DEVELOPMENT ASSESSMENT REPORT				
Application No.	REV/2021/0023			
Address	39 Short Street BIRCHGROVE NSW 2041			
Proposal	S8.2 Review of Development Application DA/2021/0603 which refused an application seeking consent for basement, ground and first floor alterations and additions to the existing dwelling-house.			
Date of Lodgement	21 December 2021			
Applicant	Benjamin R Morrison			
Owner	Benjamin R Morrison Kathryn A Morrison			
Number of Submissions	Initial: 4			
Value of works	\$1,899,396.00			
Reason for determination at Planning Panel	Recommendation reaffirms previous determination (refusal)			
Main Issues	Building Location Zone Side boundary setbacks Visual bulk and scale Character and pattern of development of the area Visual privacy Solar Access and overshadowing			
Recommendation	Refusal			
Attachment A	Reasons for refusal			
Attachment B	Plans of proposed development			
Attachment C	Statement of Heritage Significance

1. Executive Summary

CLIENT: BEN MORRISON AND KATHRYN FREEZE
 PROFESSIONAL: 160621
 ADDRESS: 39 SHORT ST BRIDGE GROVE
 DRAWING: ROOF PLAN
 REV: 02
DA-D04

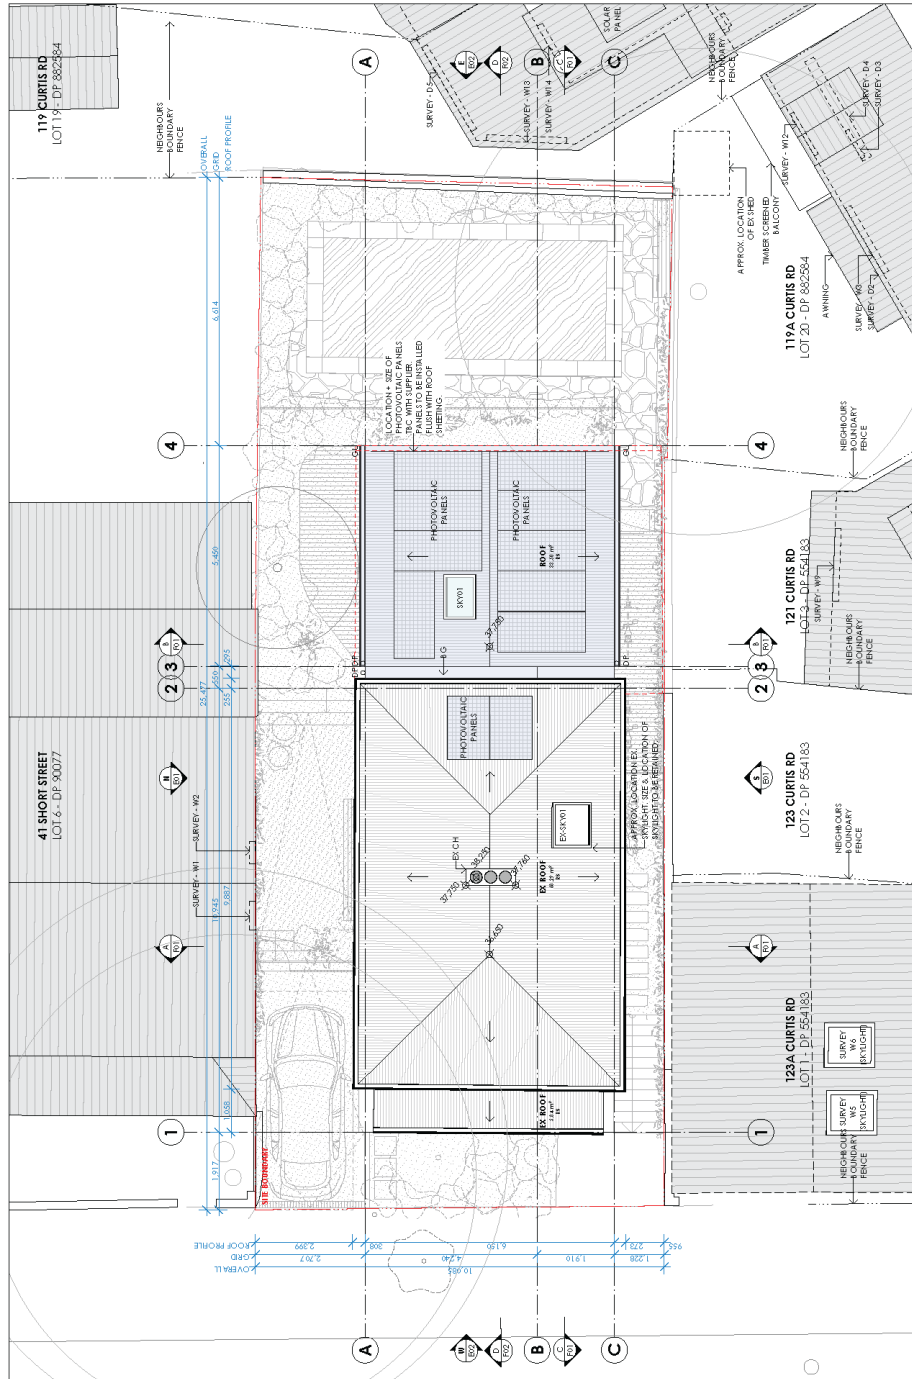
The existing skylight on the south roof plane is not to be increased in size. Any increase in size would require the demolition of the main roof form, which is inconsistent with C10 of Part C1.3 of the DCP which requires that where rear additions are visible from the public domain the original roof form must be maintained and new additions are to be sympathetic to the original roof, and C3 b. and C6 of Part C1.4 of the DCP, which requires that development within HCAs retain whole roof forms.

REVISIONS
SHADOW DIAGRAMS - WINTER
9AM
REV 02

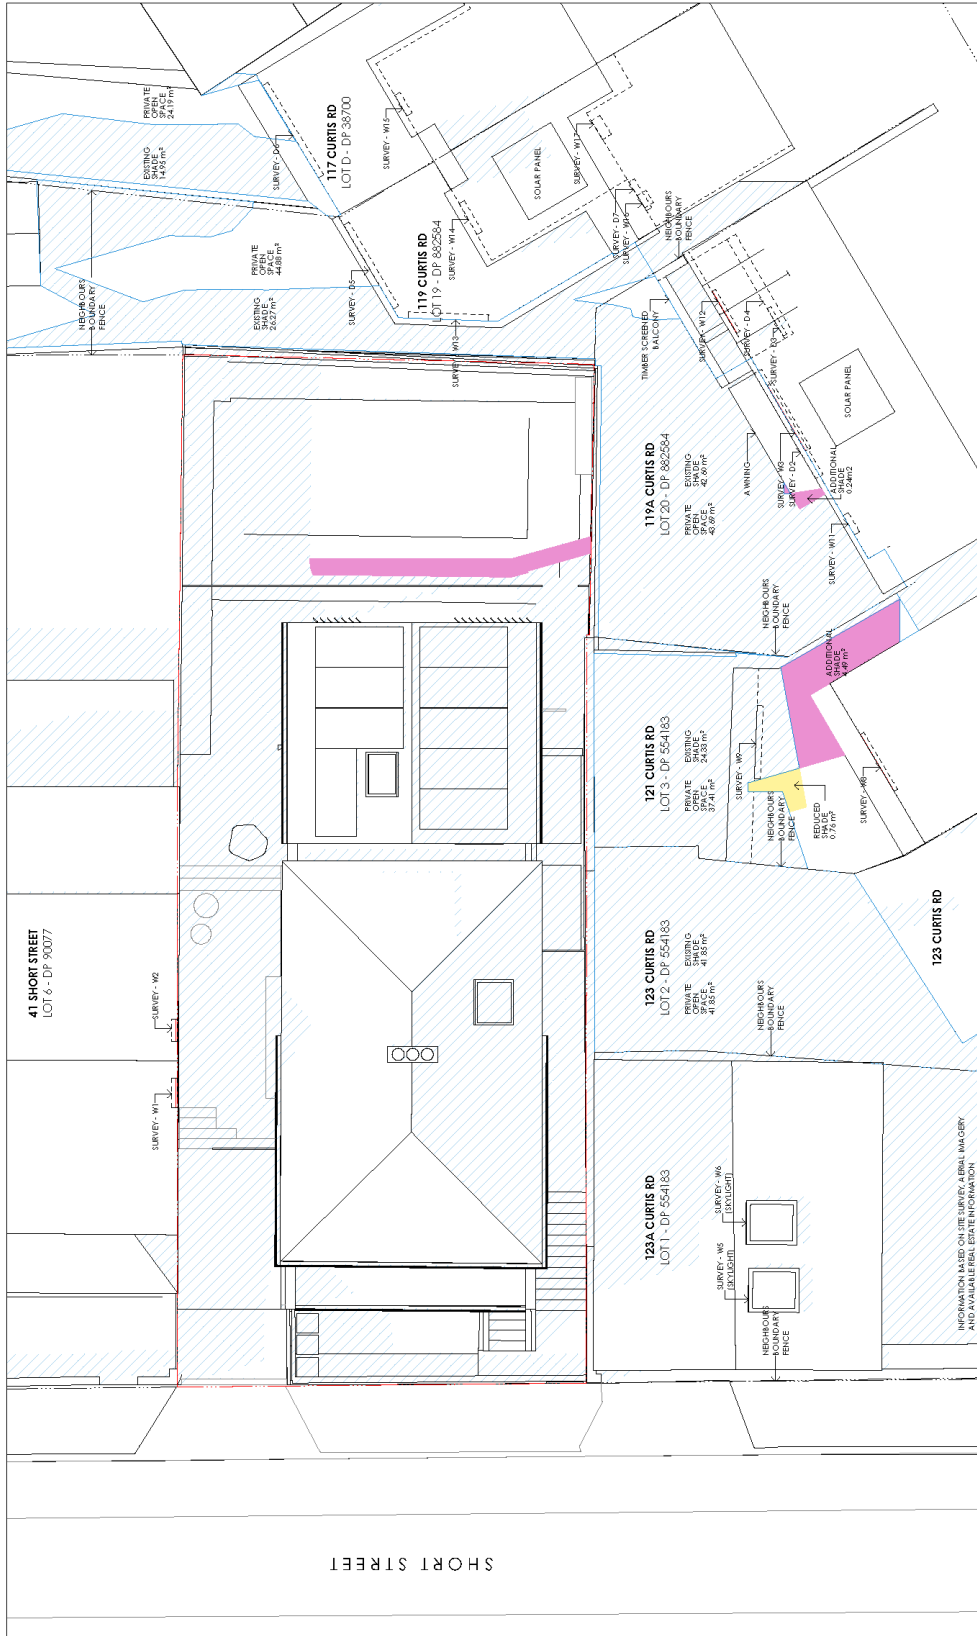
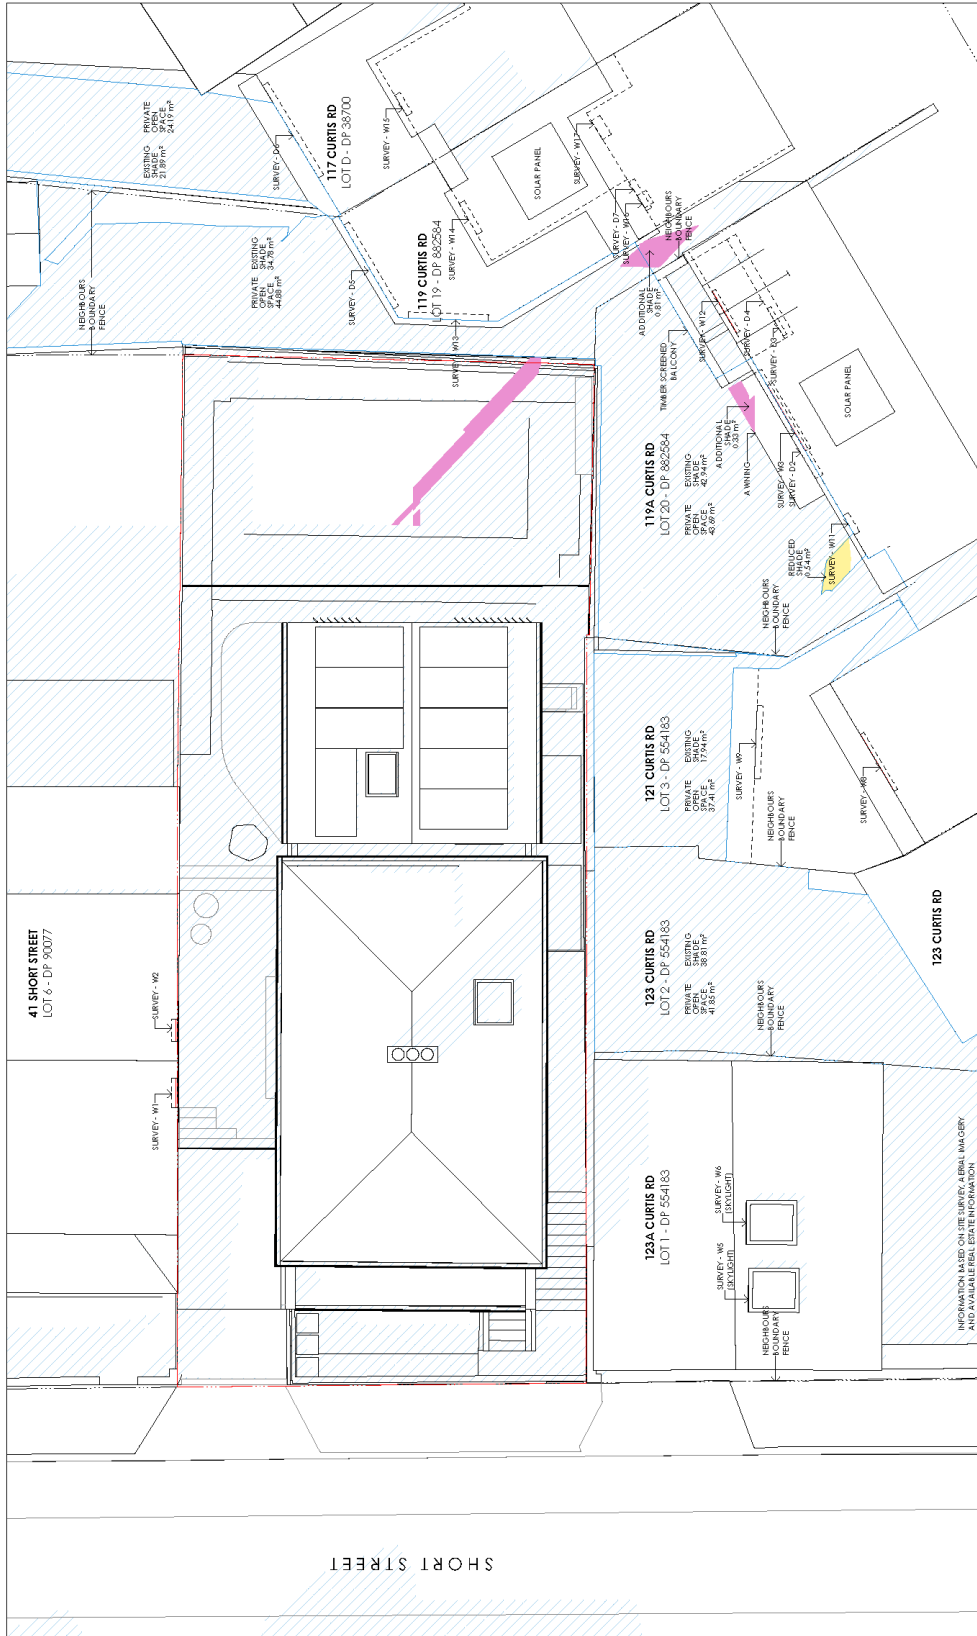
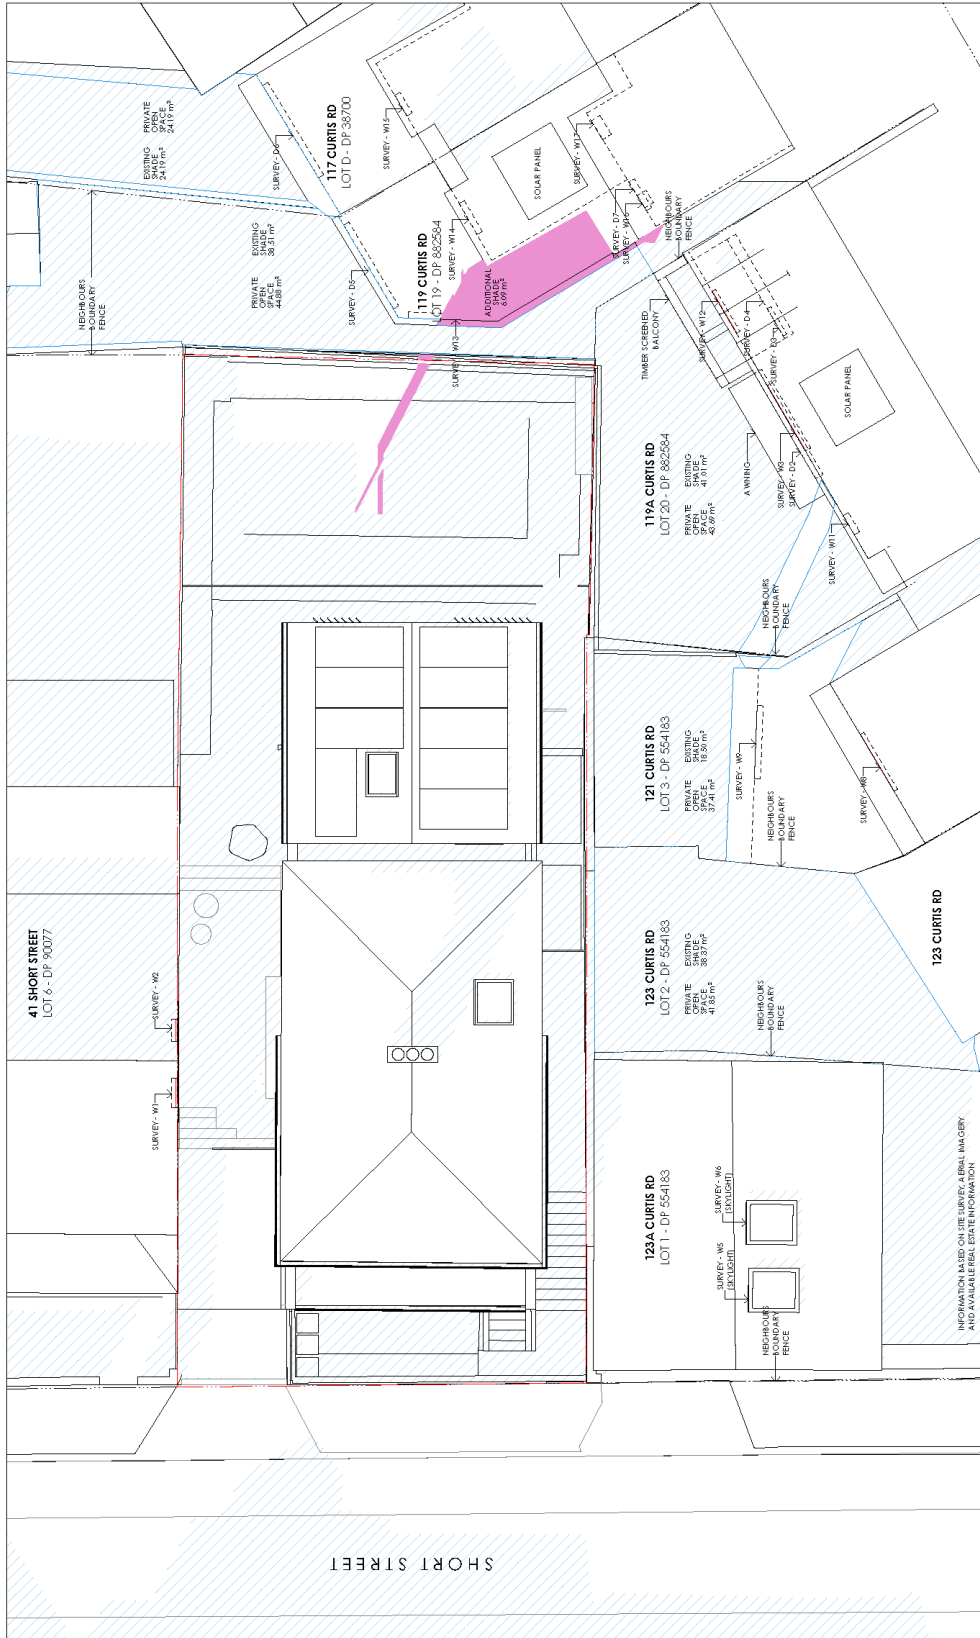
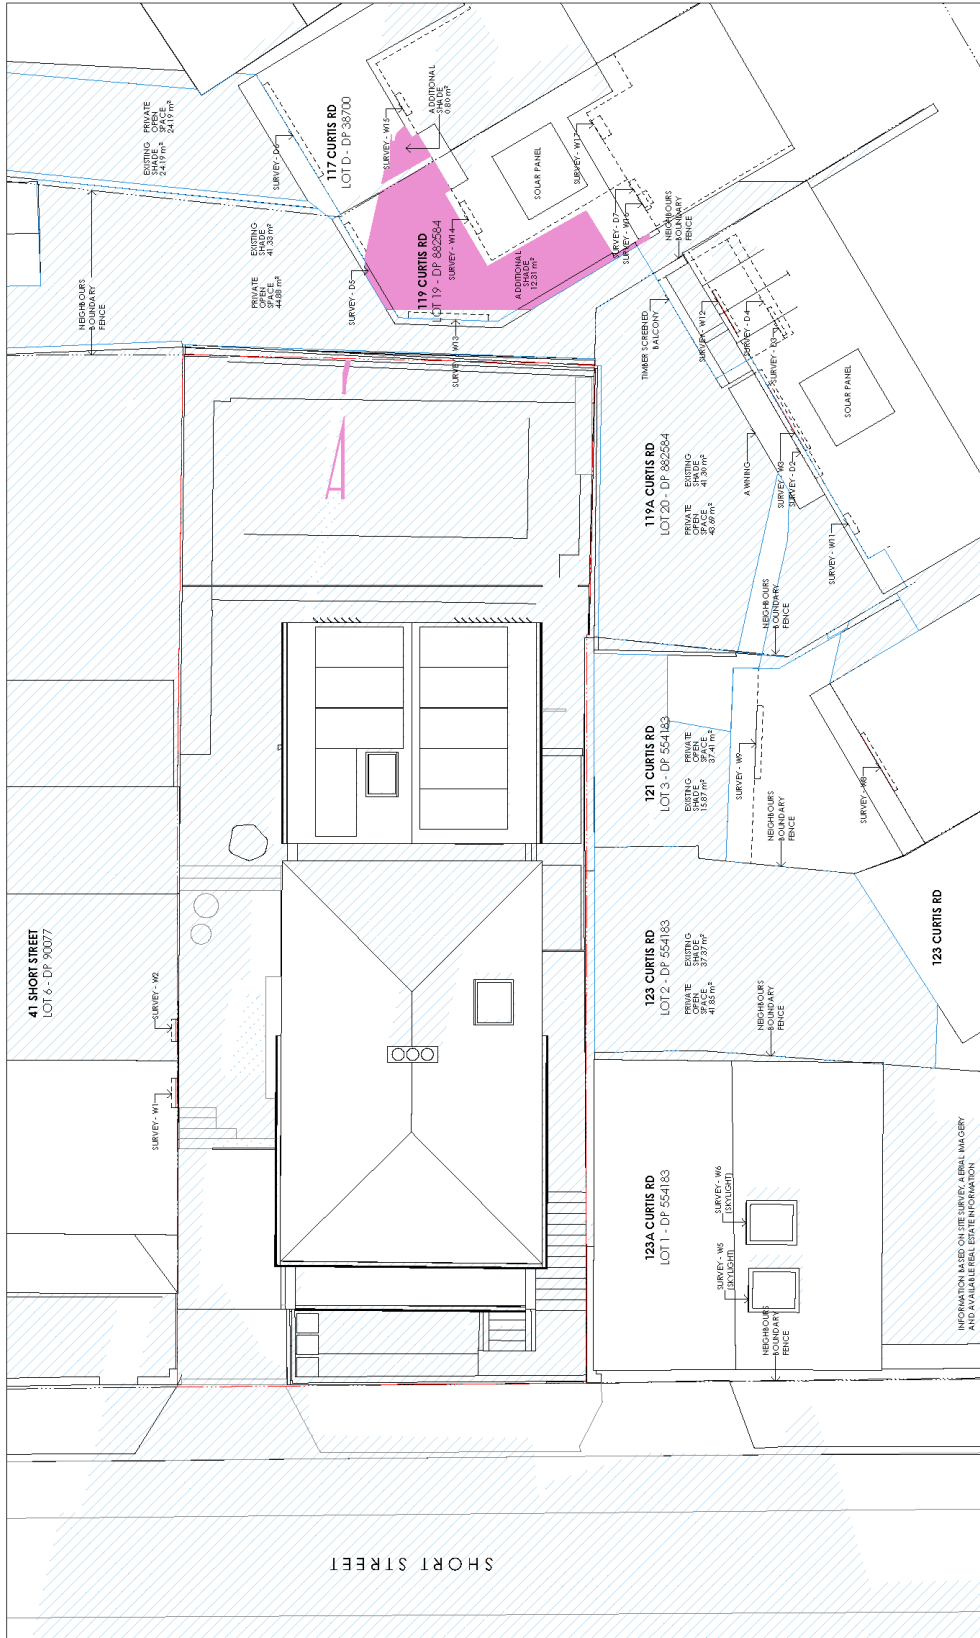
Council requested additional information from the applicant, requiring documentation to show casting lines (altitude and azimuth angles) on the shadow diagrams to assess these for accuracy. The applicant advised that they would not provide the requested information.
